JAFP-11-0102
August 16, 2011

SUBJECT: Application for Change to the Current Licensing Basis, Authorizing use of
On Load Tap Changers with the Reserve Station Service Transformers
James A. FitzPatrick Nuclear Power Plant
Docket No. 50-333
License No. DPR-59

**Technical Justification and Analysis
For
Proposed Change to the Current Licensing Basis**

Figure 1 Typical Pre Transfer Voltage Control and Limit Bands

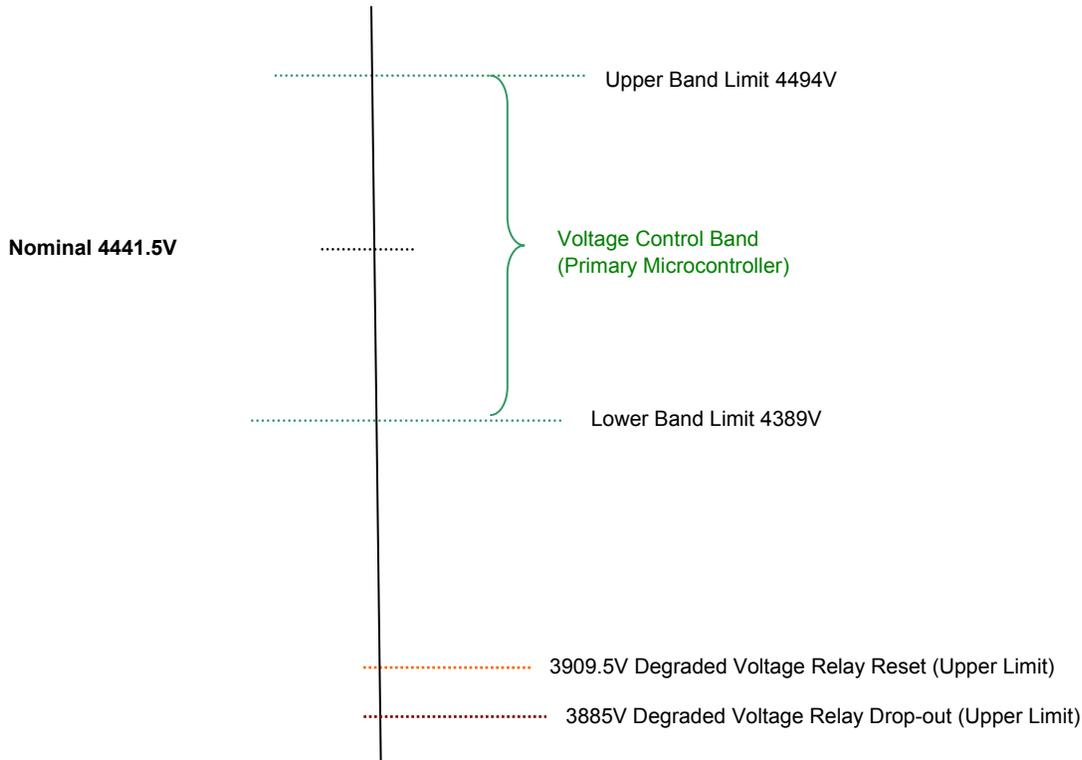
OLTC operation is based on the typical voltage bands shown in Figure 1 and Figure 2 below. Figure 1 represents the RSST's OLTC voltage and control limits in the "Pre Transfer" condition (RSST's unloaded) and Figure 2 represents the RSST's OLTC voltage and control limits in the "Post Transfer" condition (RSST's loaded). Explanation of these voltage bands is provided in the subsequent descriptions of the OLTC operation.

The backup microcontroller prevents a defective primary microcontroller from adjusting voltage outside the established undervoltage and overvoltage limits (voltage limit band - symbolized on Figure 1 as “Undervoltage Limit (Microcontroller - Block Lower Limit (V<))” and “Overvoltage Limit (Microcontroller - Block Raise Limit (V>))” respectively) by initiating alarms, blocking the raise or lower logic of the primary microcontroller (i.e., block raise logic on overvoltage; block lower logic on undervoltage), and attempting to return the voltage to the control band. If the regulated voltage goes above the Extreme Overvoltage Limit (symbolized “Extreme Overvoltage Limit V>> (Backup Microcontroller – Lower Overvoltage Limit)” on Figure 1) for a set period of time, an alarm is actuated and the backup microcontroller will initiate a lower tapchange operation. Severe undervoltage is addressed by the degraded voltage relaying. The design also allows operators to override both microcontrollers and take manual control, if necessary.
